# Access Compliance Report

## Public Rights-of-Way

### (Curb Ramps)

Intersection ID: 12046	Main Street: S_CEDAR_ST	Cross Street: W_1ST_ST	Location: E
ADA ID: BC76EF8FF68F	Ramp Type: Para	Initial Pass/Fail: Fail	Overall Compliance: No
Severity Score: 13.75			
Codes/Mitigation Info/Possible Solution		Field Measurements/Component Compliance

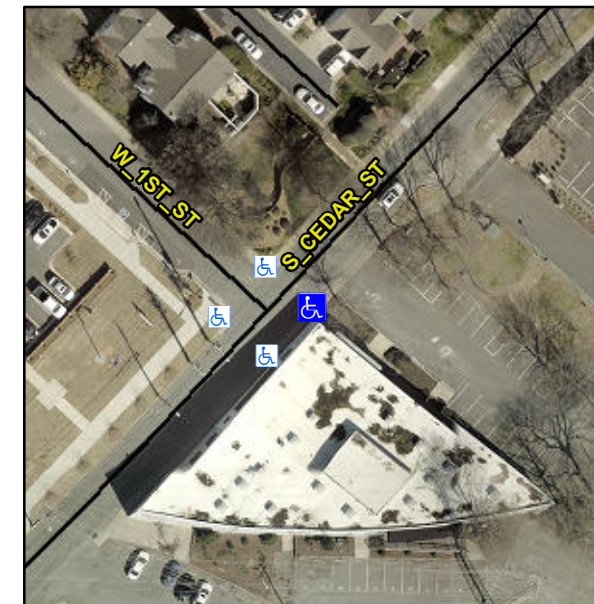
**R304.3.2, R304.5.3**

Compliance	Description	Data	Compliance	Description	Data
N/A	Ramp Length LT (in)	60.0	N/A	Ramp Length RT (in)	60.0
Yes	Ramp Width LT (in)	48.0	Yes	Ramp Width RT (in)	49.0
No	Ramp Slope LT (%)	9.6	Yes	Ramp Slope RT (%)	4.0
No	Ramp XSlope LT (%)	3.7	No	Ramp XSlope RT (%)	2.3
N/A	Landing Length (in)	N/A	N/A	DWS Provided?	N/A
N/A	Landing Width (in)	N/A	N/A	DWS Contrast?	N/A
N/A	Landing Slope (%)	N/A	N/A	DWS Length (in)	N/A
N/A	Landing X Slope (%)	N/A	N/A	DWS Full Width?	N/A
N/A	Landing Curb? (Y/N)	N/A	N/A	DWS Offset (in)	N/A
N/A	Shared Landing?	N/A			
N/A	Gutter Ponding?	N/A	N/A	Gutter Slope (%)	N/A
N/A	Gutter Lip Ht (in)	2.0	N/A	Gutter X Slope (%)	N/A
N/A	Painted X Walk1?	No	N/A	Painted X Walk2?	N/A
	X Walk 1 Direction	To NW		X Walk 2 Direction	N/A
N/A	X Walk 1 Width (in)	N/A	N/A	X Walk 2 Width (in)	N/A
	X Walk 1 Slope (%)	5.4		X Walk 2 Slope (%)	N/A
	X Walk 1 X Slope (%)	5.1		X Walk 2 X Slope (%)	N/A
N/A	Ramp inside XWalk1?	N/A	N/A	Ramp inside XWalk2?	N/A

**Remove & Replace Entire Ramp.**
